# **Design Excellence Report**

## **Tallawong Station South**

### **SSDA 9063**

May 2018

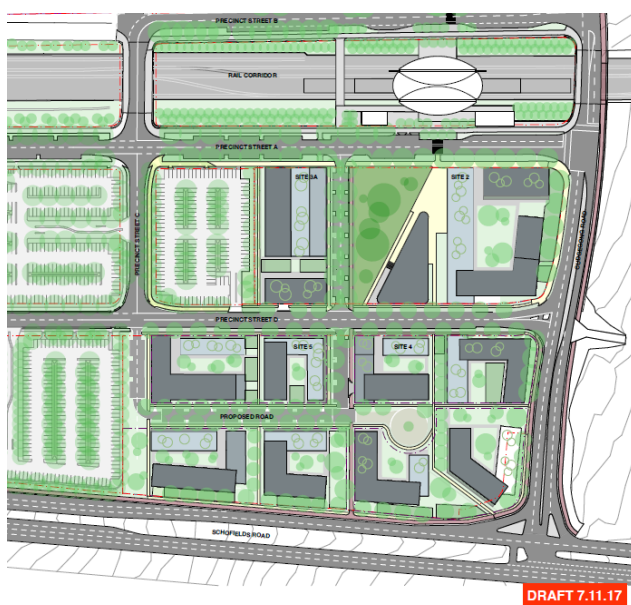
In April 2017 the initial concept for the site was presented to the Design Directorate. The initial concept is shown below.

The Directorate recommended reconsideration of proposed street and public domain organisation, lot sizes and heights to provide:

- a greater variety and diversity of built forms
- reduced block sizes to provide greater permeability, better walkability and support better activation at street level
- increased range of dwelling types (for example terrace-type ground floor apartments)
- a variety of public domain, street and activation experiences, notably through the exploration of shared zones within streets and different type of streets.

The Landcom development team and the design team explored how to meet the objectives set by the Design Directorate and embed the Directorate's recommendations in the concept plan and the design excellence process for the next stages.

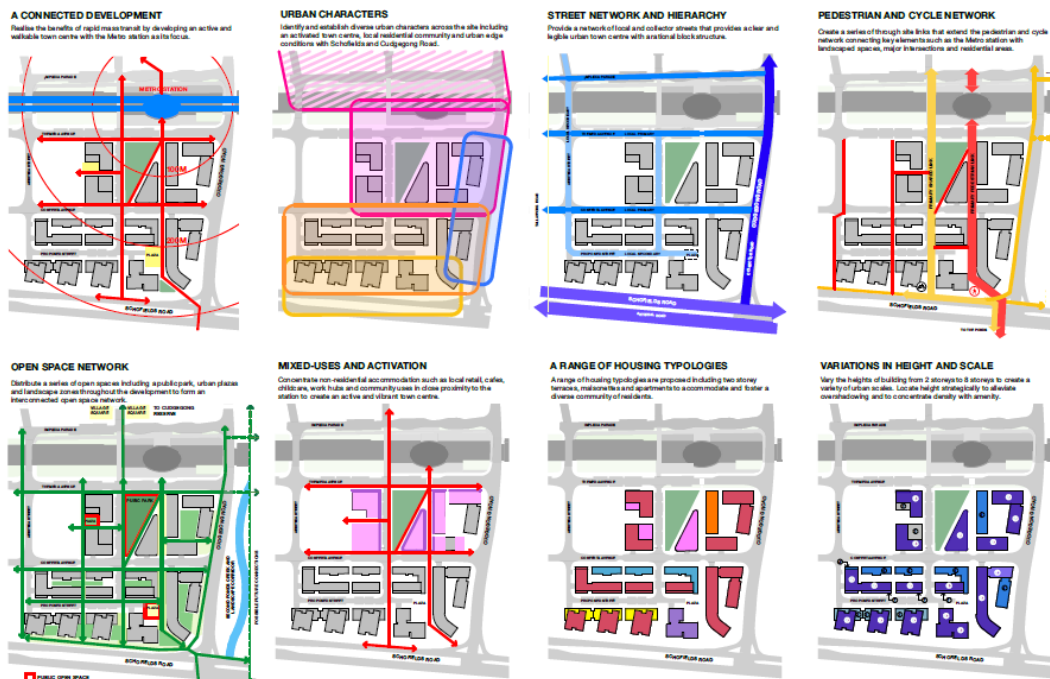
GANSW provided additional feedback on the Concept Proposal requesting:

- consideration of social impacts including open space provision
- further strengthening Design Quality Guidelines on function of open space, deep soil planting, public/private interface, street types, fine grain, address to Schofields Road and Cudgegong Road
- more information on divestment and design excellence.

These matters are addressed in the *Public Domain and Landscape Strategy*, *Social Needs and Impact Assessment*, *Design Quality Guidelines*, this *Design Excellence Report* and the *Environmental Impact Statement* for the Concept Proposal. The *Design Quality Guidelines* will be applied as part of the Design Excellence Strategy.
